IRVIN 182.03 ACRE TRACT MASTER DEVELOPMENT PLAN

555 EAST RAMSEY | SAN ANTONIO TEXAS 78216 | PHONE: 210.375.9000
FAX: 210.375.9010
PREPARATION DATE: JUNE 14, 2005 | JOB NO. 6219-00

555 EAST RAMSEY SAN ANTONIO TEXAS 78216 PHONE: 210.375.9000
FAX: 210.375.9010
PREPARATION DATE: JUNE 14, 2005 JOB NO. 6219-00
REVISED DATE: SEPTEMBER 8, 2005

City of San Antonio
Development Services Department
Master Development Plan
APPLICATION

IRVIN 182.03 ACRE TRACT MASTER DEVELOPMENT PLAN

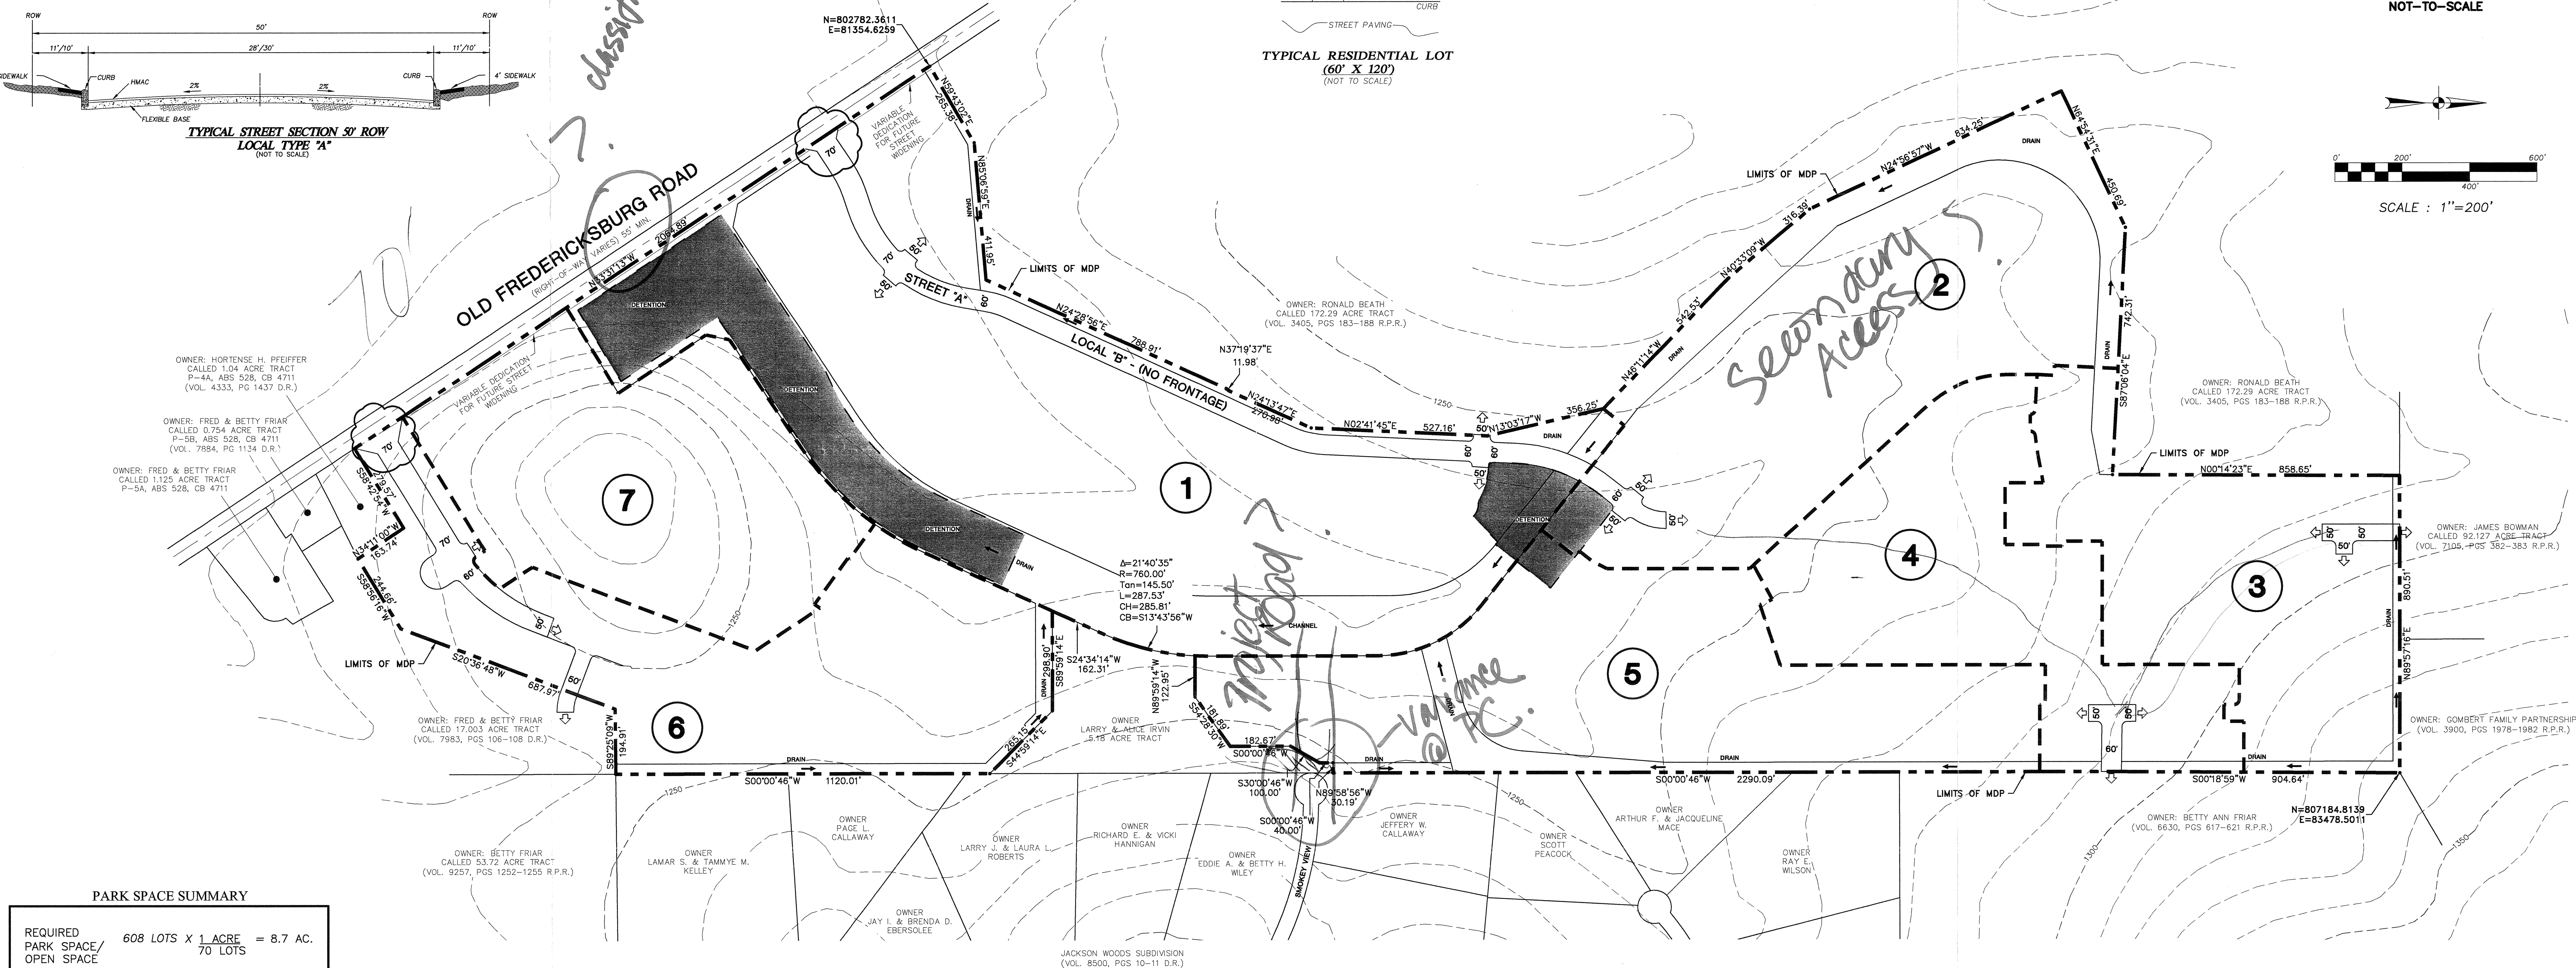
1. Based upon the information provided, the above referenced MDP is approved with the following condition: add a note stating that block lengths shall comply with UDC Section 35-515(b)(3)".
2. It should be understood that this is a general review of a conceptual plan and that ***all*** technical requirements of the Unified Development Code for Streets & Drainage shall be complied with.

- Zoom-in of site layout (current site layout in TIA is too small).
- Show Local A connection into Lost Creek IV.
- Existing traffic counts @ Old Fredericksburg & IH 10 Access Rd.
- Pavement condition.

Old Fredericksburg is classified as a collector street by both the City and the County, requiring 70 feet of ROW (35' C/L to PL). The MDP is required to show the dedication given only a 60' ROW. Thanks.

With respect to the street system, the connection of the proposed Collector and Local B roads do need to be shown on the Master Development Plan. This will help us ensure that these roads will connect in the future to provide secondary access to all units within this development. I understand that you may not want to commit to the specific path of the road system at this time, but we do need to the plan to show an intent to connect the roadways.

1. According to our Streets Division, Old Fredericksburg Road is classified as a Collector and will need to be upgraded to provide 70' ROW.
2. The collector systems shown in Phases 1, 4, and 3 need to be connected so we can see the circulation. Without this connectivity it is difficult to determine if adequate secondary access will be available.
3. Projection of Smokey View Road. It appears that this roadway is intended to continue into future development. There is a small section of Irvin property between this MDP and the roadway projection. Please indicate how this roadway is to be accounted for. Perhaps a supplemental could show the intended lot layout for this section of Phase Five. I realize there are some drainage features, but nothing that specifically precludes planning for the project of this roadway.

10. BLOCK LENGTHS SHALL COMPLY WITH UDC SECTION 35-515 (b)(3).
11. PRIOR TO ANY PLAT APPROVAL AND OR RECORDATION A SUPPLEMENTAL PER UDC 35-B(C)(18) SHALL BE SUBMITTED FOR REVIEW AND APPROVAL TO COMPLIANCE OF THE UDC.

12. STREET "A" WILL REQUIRE A LEFT TURN LANE AND A RIGHT TURN DECEL LANE AT OLD FREDERICKSBURG ROAD.

Revisions as per comment of Sept. 1, 2005.

QUANTITY	DESCRIPTION
1	REVISE PLAN WITH LOCAL "A" CONNECTION TO LOST CREEK IV (FRIAN TRACT)
